ANN ARBOR HISTORIC DISTRICT COMMISSION

Staff Report

ADDRESS: 618 South First Street, Application Number HDC25-0062

REPORT DATE: June 12, 2025

Back Wall Current Elevation Drawing

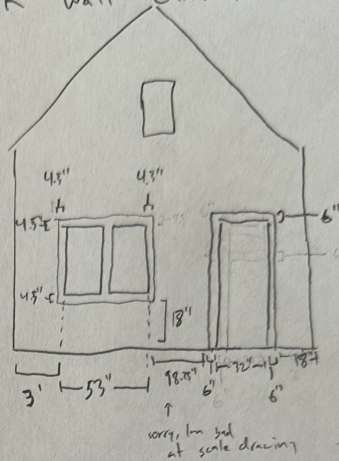
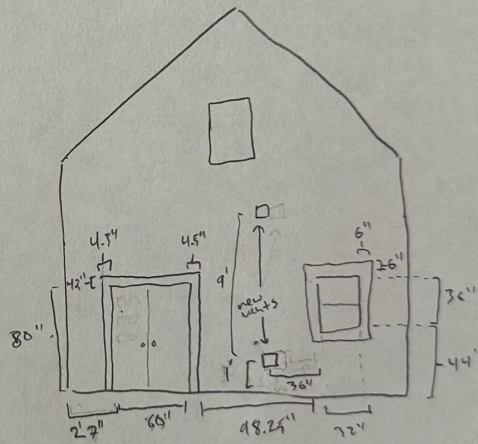
1. The rear elevation of this small house is quite simple. The back porch does not appear on 1931/1948 Sanborn Fire Insurance Maps, so it is assumed to not be from the period of significance for the historic district, which ended in 1944. There is no mention of removing it in the application. The windows have been replaced with vinyl windows, and the back door has also been replaced.
2. The owner/applicant originally proposed to use matching wood trim around the new window and doors, but after talking to staff says he will vary it by making all trim 4" width. This is appropriate. The new pair of doors are 60" x 80", 15-lite clad wood with applied muntins and spacers. The new windows are 32" x 36" clad wood, also with applied

3. The two 8" kitchen vents on the rear elevation and the 4" bath vent on the south elevation are in appropriate locations.
4. Since no unique character-defining features would be lost for the work, and since the work is not visible from the street, staff believes it is appropriate.

Window → Door

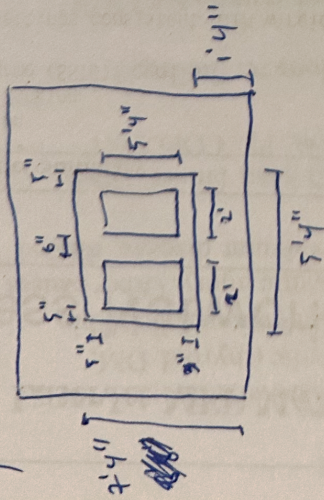
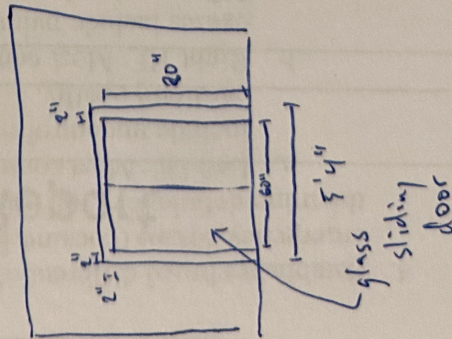
muntings and spacers. Staff believes either these simulated divided lite doors and window or single-lite are appropriate.
